**SD PHASE MEETING MINUTES****DATE** April 26, 2012**FROM** Michael Jacobs, AIA, CID, LEED AP
Principal Architect**TO** Rob Knarr, PE (for distribution to NKU)
Project Manager**SUBJECT** **Campus Recreation Center**
Northern Kentucky University
Highland Heights, KY**6a**

Schematic Design Review**9:00am – 12:00pm****SU 108**

Scheme A
 First Floor Plan
 SD Meeting #2
 April 26, 2012

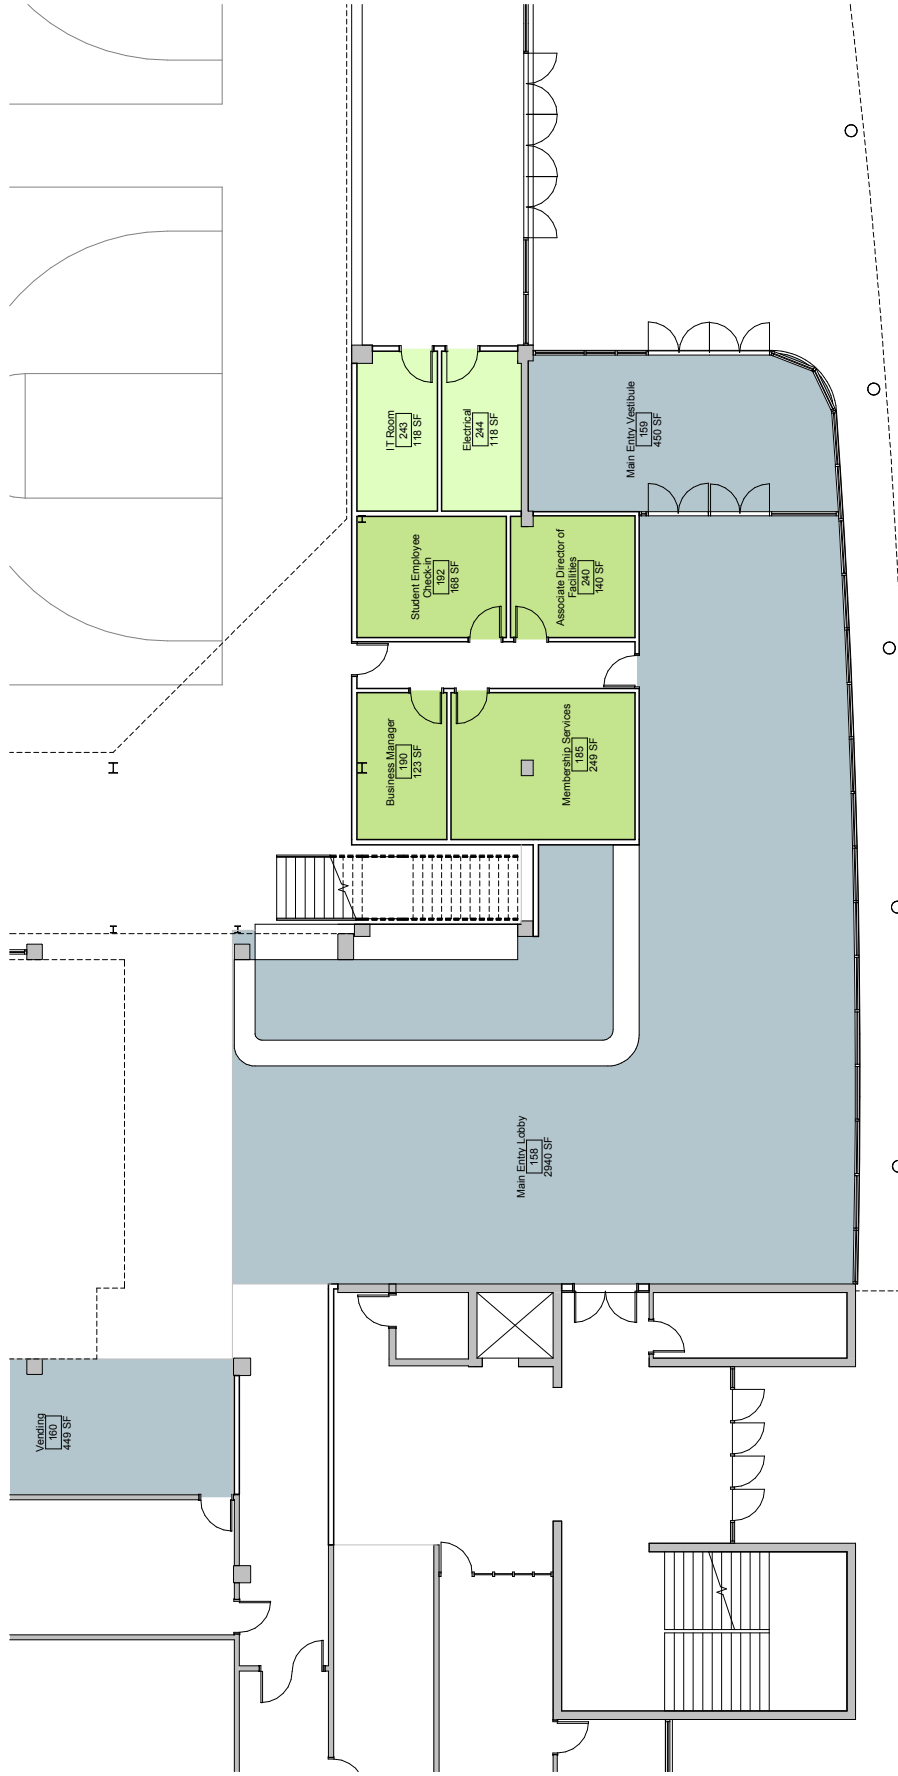
- Matt was concerned that the fitness areas have become too public spread through the main axis of the building. David noted the need to fill the large void-like shape with activity

- Matt preferred the previous layout where a fitness area was located where the bouldering is on the new plan. He would prefer that the fitness that is now located next to the MAC switch locations with the current location of bouldering.

- Larry stated that some fitness areas would need to be somewhat private
- Mary Paula stated that the glass walls/dividers between the fitness areas do not have to be transparent.

- Matt stated that bouldering should be relocated to the north wall of the racquetball courts to have more exposure inside the building which would cover one of the proposed glass walls of the racquetball courts. He would rather advertise bouldering instead of racquetball

- Mary Paula asked if the current floor plan was indicating enough room for gym storage. The design team will review.
- Matt stated that the MAC area was not indicating a storage area. The design team will locate on the plan. The design team also will add 3 exits, bench, and goals.

- Reed suggested that the east wall of the new locker rooms next to the recreation pool be pulled back to allow for a view into the recreation pool from the main corridor on the interior of the building.

- Larry asked if the central stair located in the exterior recreation area was necessary and asked if a ramp should be shown. The design team will review.

- The current pool configuration as shown would require the use of a "bulkhead" installed between the lap lanes and the recreation area for competitions.

Scheme A
Second Floor Plan
SD Meeting #2
April 26, 2012

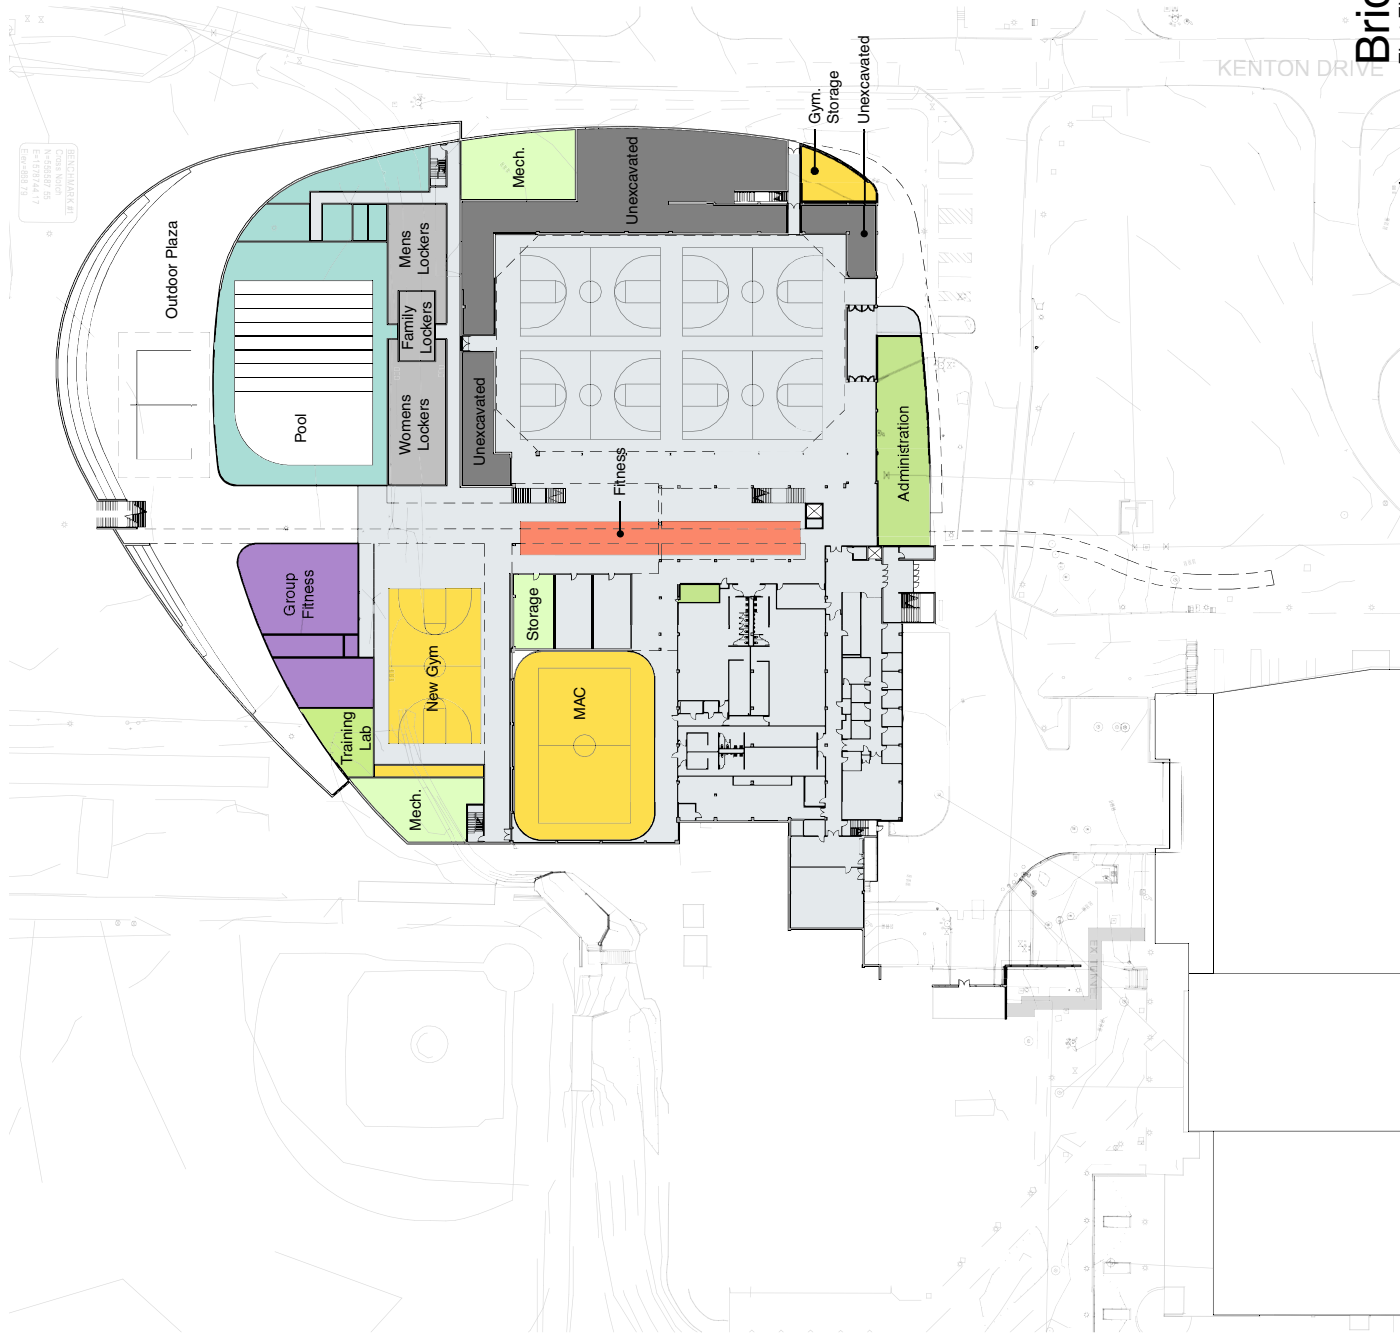
- Michael noted that the new second floor area in the addition on the south end of the building (on the entry axis) could be opened up to the 1st floor area to minimize the square footage/circulation area where the "Lounge Area" is shown.

Bridge Scheme

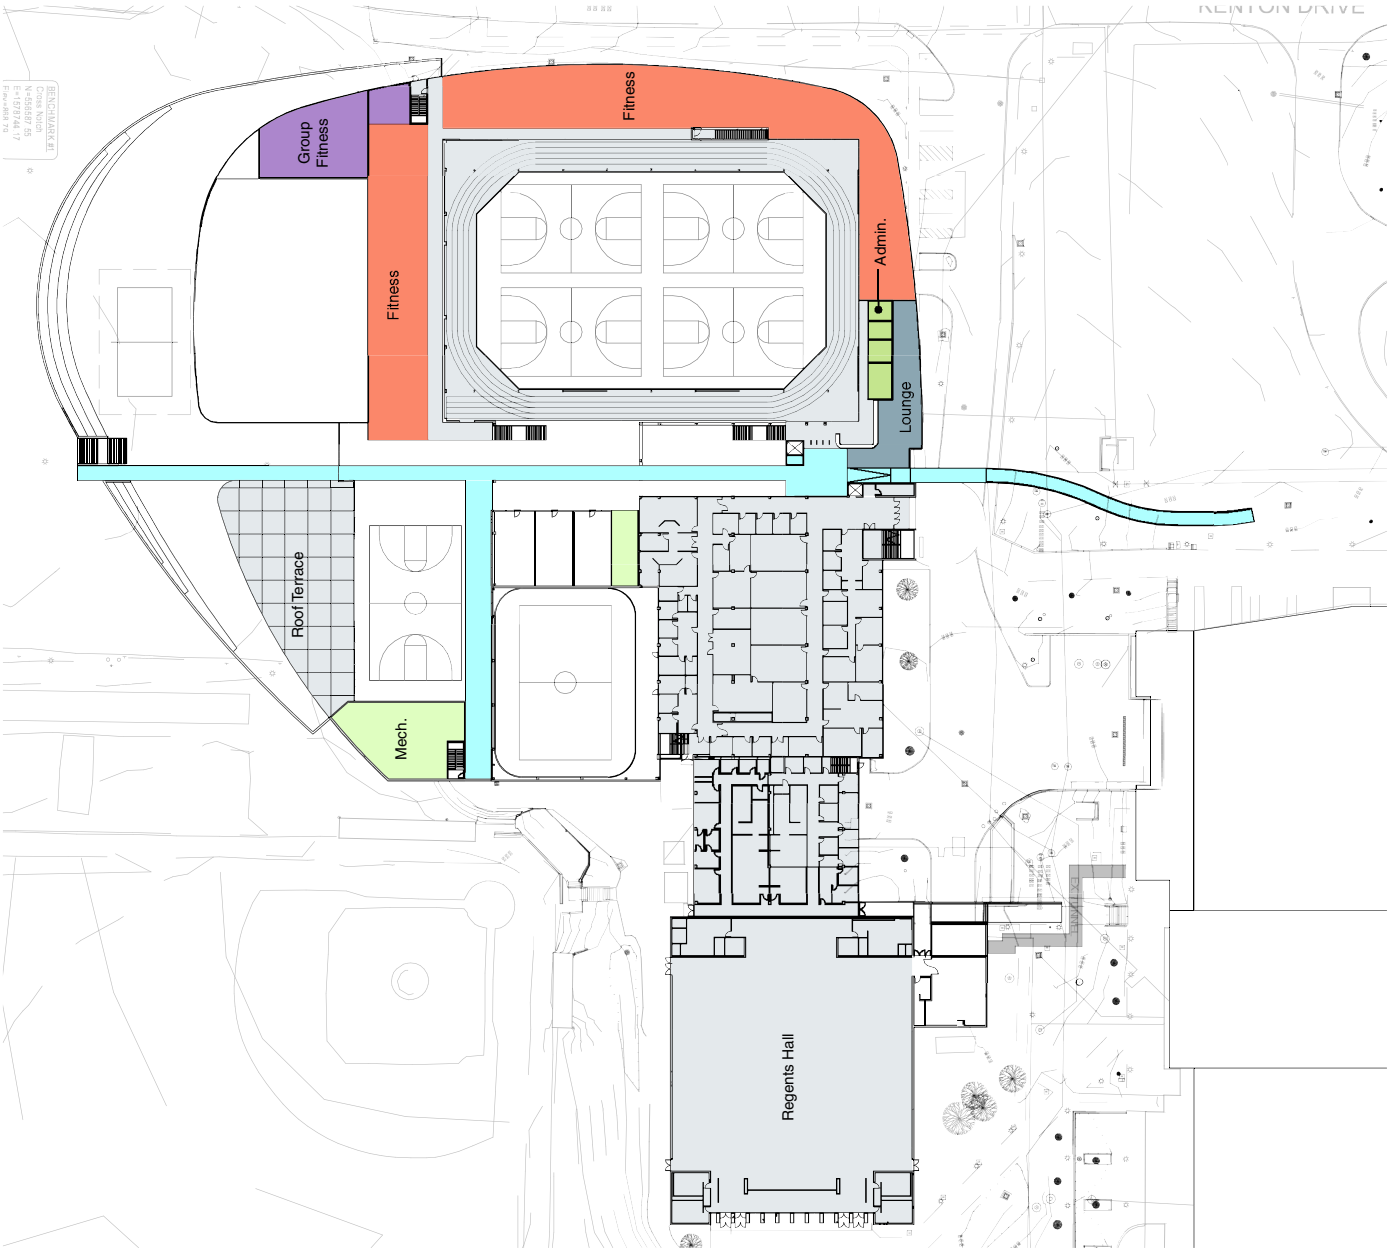
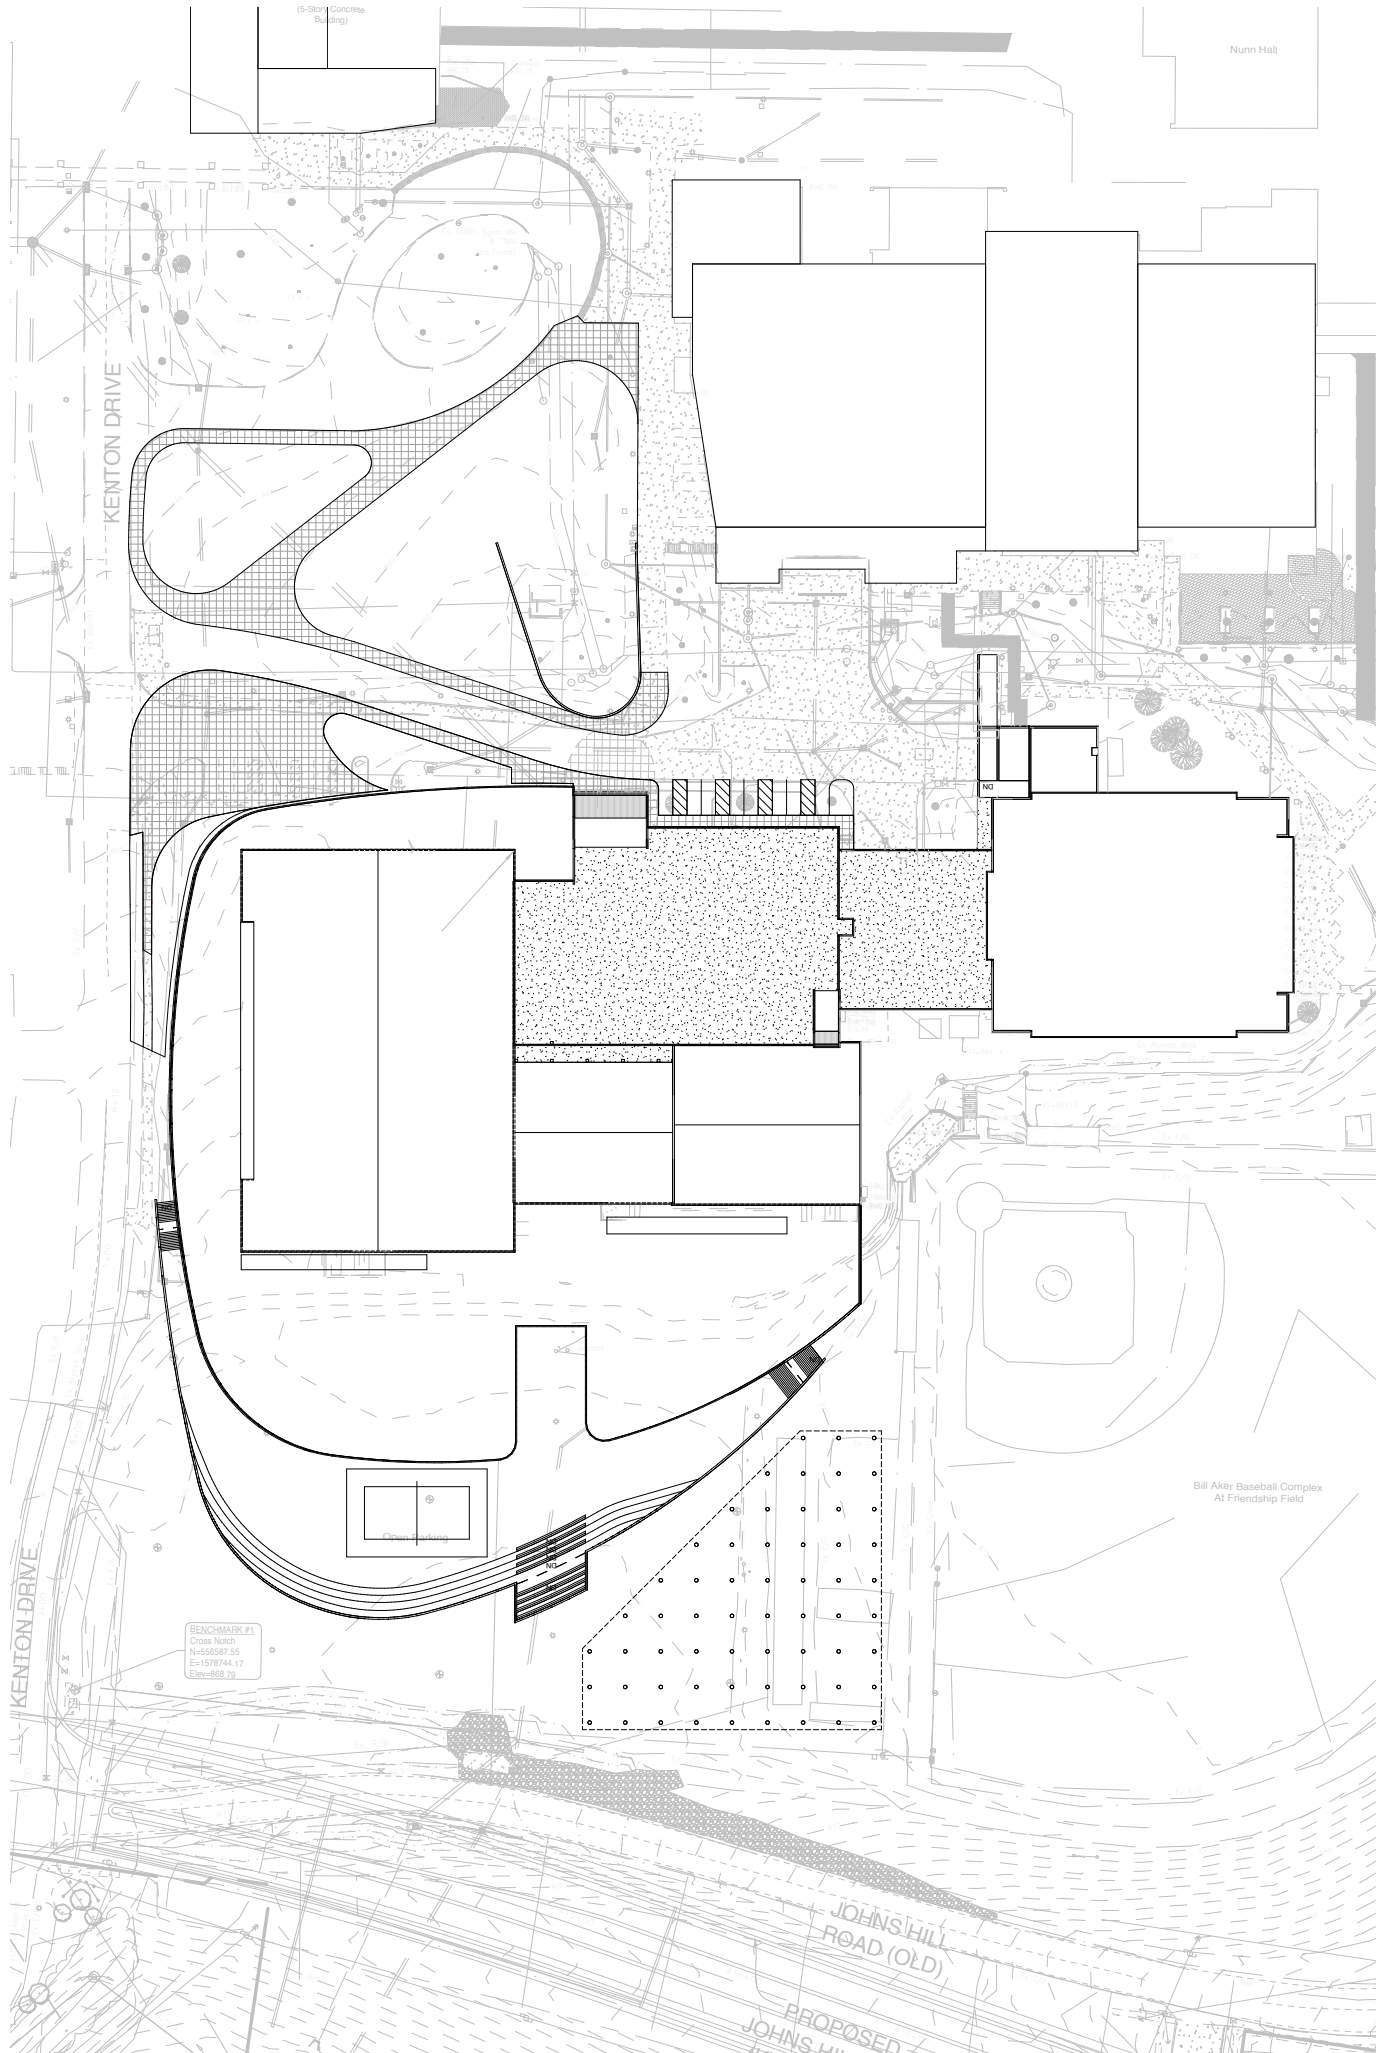
- The design proposes a "bridge" from the Student Union lawn to the 2nd Floor entry in the new recreation center.
- The design would eliminate the 2nd Floor Albright Center restrooms, which would require the cost of new restrooms to be located on the 2nd Floor of the new recreation center and provide unrestricted access to them from the recreation center.
- The design creates an "up and back down" movement to get into the new recreation center. It was discussed if this movement is counter productive to creating a simple movement through the building.

- Larry stated that he did not envision the bridge concept to continue through the building. He thought people would enter and move down a set of stairs to an area before the secure entry point.

- Mary Paula stated that the Recreation Center needs some physical cue that identifies the entry point.
- It was noted that the bridge in the bridge design would be a way of physically identifying "entry" to the building.
- It was noted that there are multiple ways to identify entry instead of a "bridge"
 - Placing a sculpture in the entry plaza
 - A variation in the height of the new façade
 - Using graphics and signage to designate entry
- Vivian stated that the Student Union yard could be reorganized to establish a new circulation pattern and create a shared and new campus courtyard and drop-off between the Student Union, Griffin Hall and the new Recreation/Albright Center.
- Matt stated that the main entry to the new Recreation Center should not utilize the existing entry doors of the Albright Center, the new entry as currently planned is a lot better.
